International Aero Engines SERVICE BULLETIN

Subject: Transmittal of Revision 2 to Service Bulletin
No.V2500-ENG-72-0037

**ENGINE - LP TURBINE - REPLACE THE LP TURBINE SHAFT REAR END
SEALING RING**

V2500-ENG-72-0037

Modification of the Sealing Ring
Figure 1

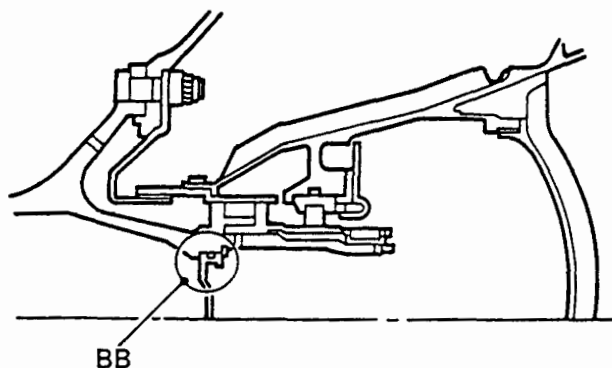
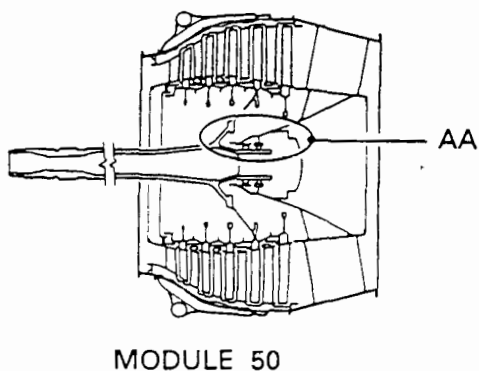
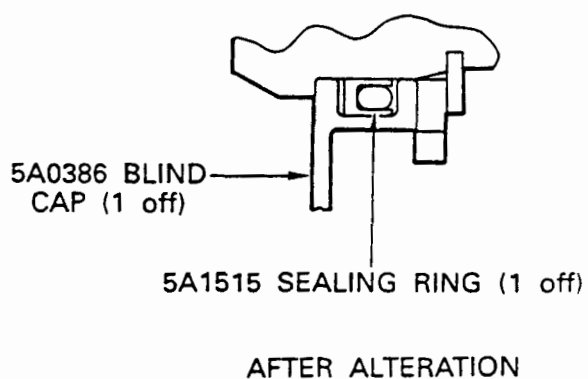
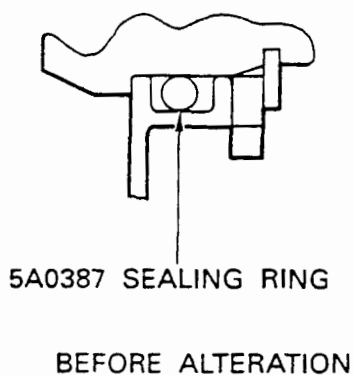
- (1) The changes introduced by this Service Bulletin are as follows
(See Figure 1):

- (a) The configuration of the Sealing Ring was changed.
- (b) Existing Part Number of the Sealing Ring has been changed to a new Part Number.

Installation of the Sealing Ring onto the Blind Cap
Figure 2

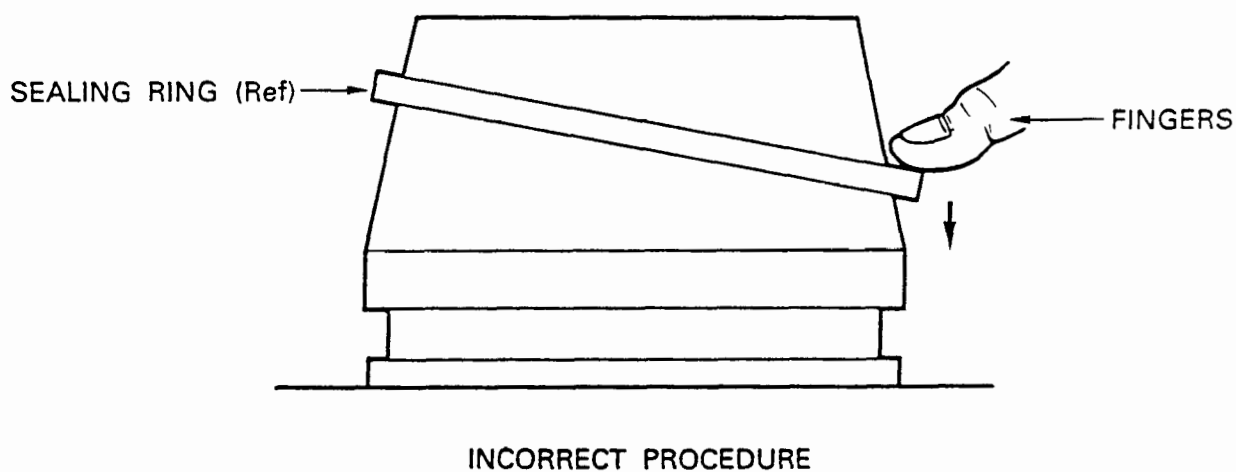
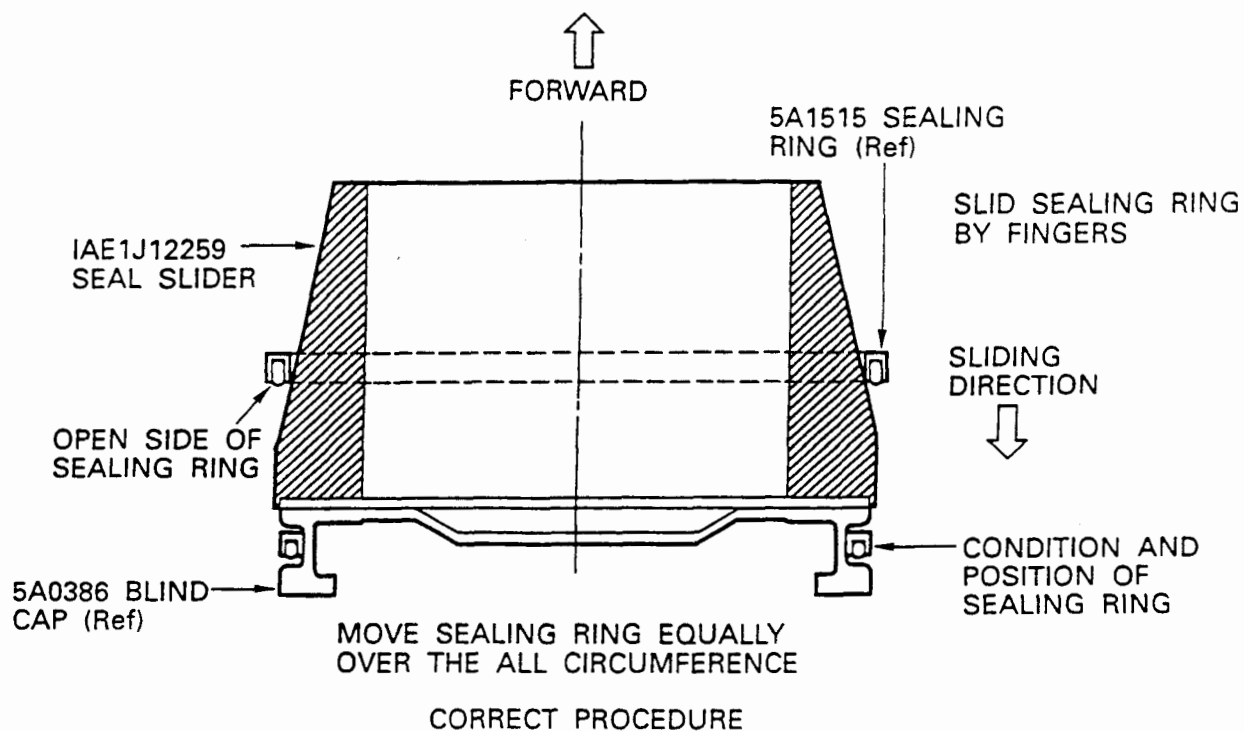
- R (1) Part 1: Installation procedure of Sealing Ring with tools.
- R (a) Install the new 5A1515, Sealing Ring into the groove on the Blind Cap
R (Refer to Figure 2).
- R 1) Put the Blind Cap on to the work bench with rear end down.
- R 2) Install the IAE1J12259, Slider onto the Blind Cap.

- 3) Lubricate the Sealing Ring with CoMat 10-077 approved engine oil.
- 4) Lubricate outer diameter surface of the slider with CoMat 10-077 approved engine oil.
- 5) Put the Sealing Ring on to the outer diameter of the slider.
The open side of the Sealing Ring must be in down direction.

- 6) Slowly push down the Sealing Ring by hand until it is installed into the groove of the Blind Cap.
- 7) Remove the slider from the Blind Cap.

Installation of the Blind Cap in to the Sizing Sleeve
Figure 3

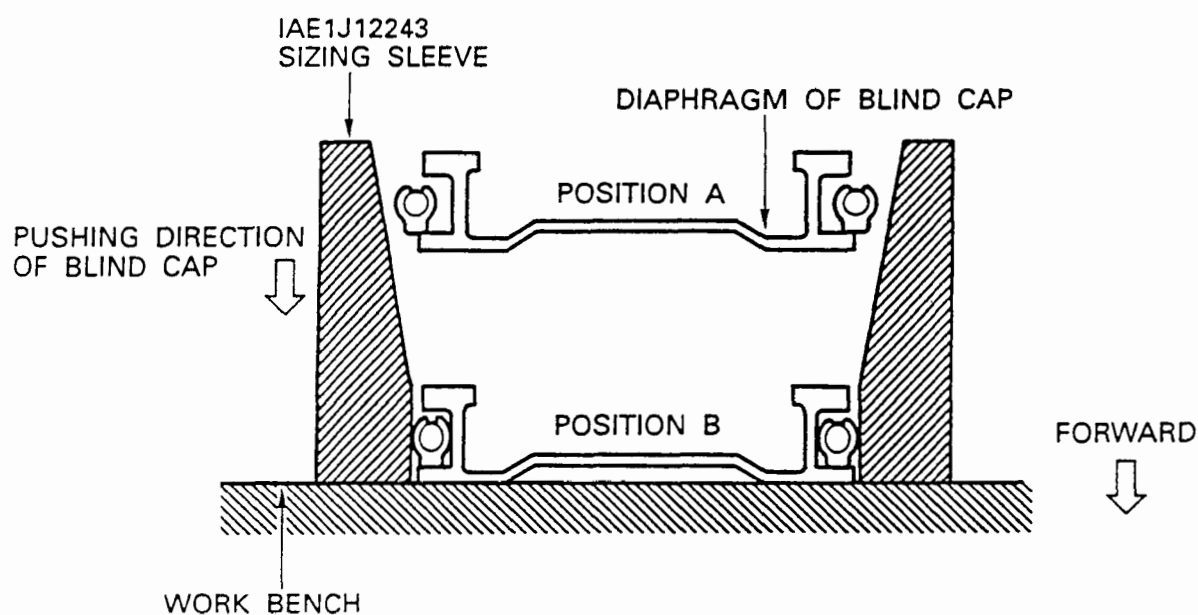
- (b) Make the shrinkage satisfactory of the Sealing Ring on the Blind Cap (Refer to Figure 3).

- 2) Lubricate the inner diameter face of the Sizing Sleeve and the outer diameter of Sealing Ring with CoMat 10-077 approved engine oil.
- 3) Put the Blind Cap in to the Sizing Sleeve. Diaphragm of the Blind Cap must be in down direction (At position A shown in Figure 3).
- 4) Slowly push the Blind Cap down until it touches the work bench (At position B shown in Figure 3).
- 5) Keep the Blind Cap in the Sizing Sleeve for 10 or more minutes.
- 6) Remove the Sizing Sleeve from the Blind Cap.

Installation of the Sealing Ring on to the Blind Cap
Figure 4

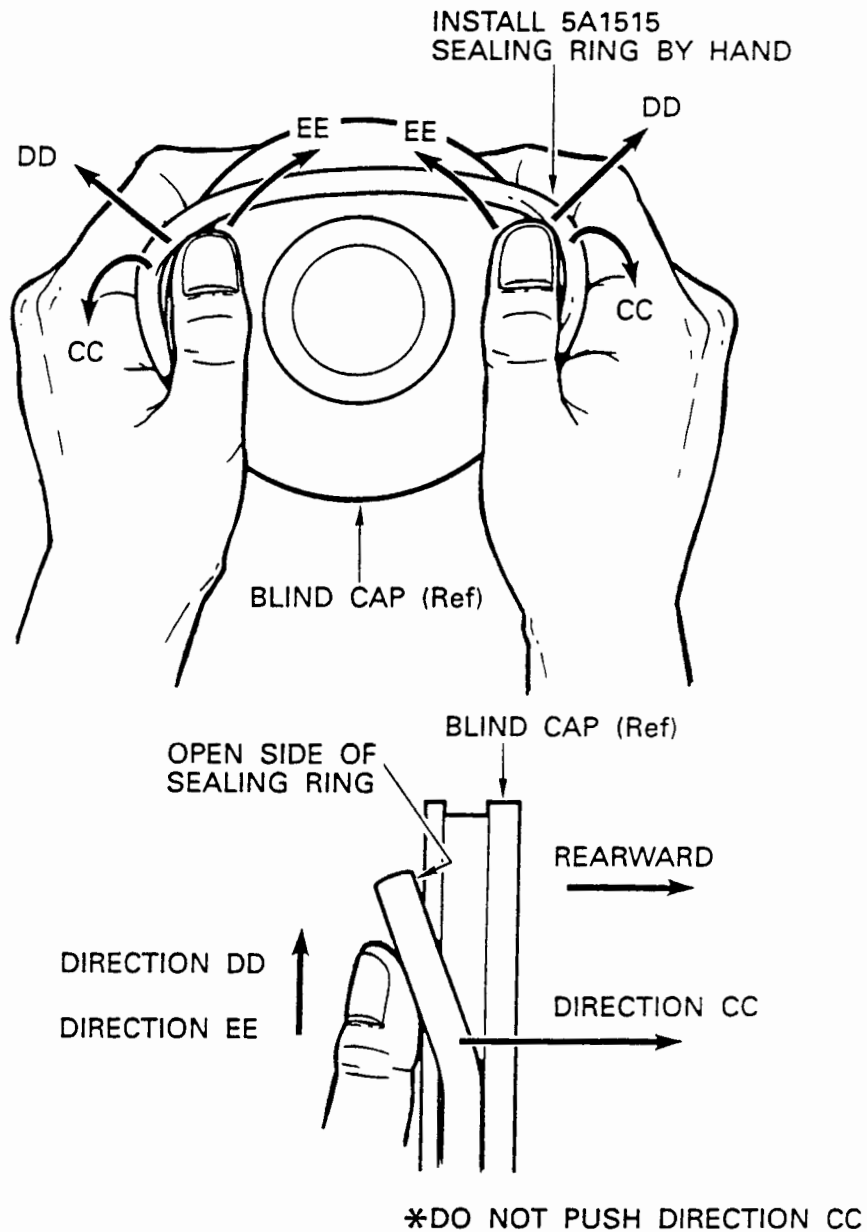
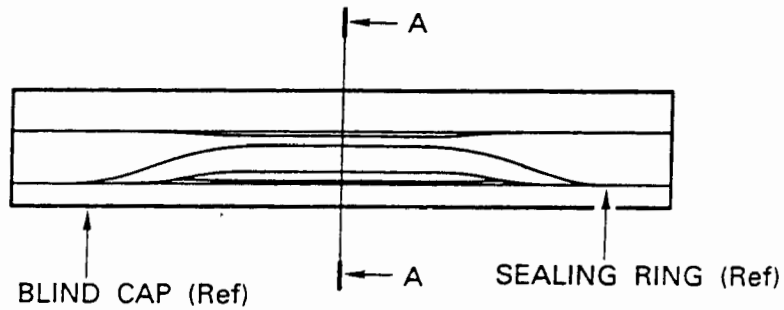
- 2) Make sure that the Sealing Ring is not twisted (Refer to Figure 5).
- (2) Part 2: Installation procedure of Sealing Ring without tools.
 - (a) Install the new 5A1515, Sealing Ring in to the bottom half of groove on the Blind Cap (Refer to Figure 4).
 - 1) Lubricate the Sealing Ring and the Blind Cap with CoMat 10-077 approved engine oil.

CAUTION: DO NOT PUSH THE SEALING RING IN DIRECTION CC SHOWN IN FIGURE 4, BECAUSE EDGE OF THE BLIND CAP CAN CAUSE DAMAGE OR TWIST TO THE SEALING RING. THE DEFECTIVE SEALING RING CAUSES OIL LEAK.

- 2) Install the Sealing Ring in to the bottom half of the groove of the Blind Cap and open side of the Sealing Ring must be rearward.
- (b) Install the Sealing Ring around all the groove of the Blind Cap (Refer to Figure 4).
 - 1) Push the Sealing Ring inner face in direction DD with finger sides to let the Sealing Ring go in to the groove of the Blind Cap.
 - 2) Move the fingers in direction EE.
 - 3) Repeat steps 1) and 2) until the Sealing Ring is installed around all of the groove.
- (c) Visually examine the Sealing Ring.
 - 1) Make sure that there is no damage on the surface.
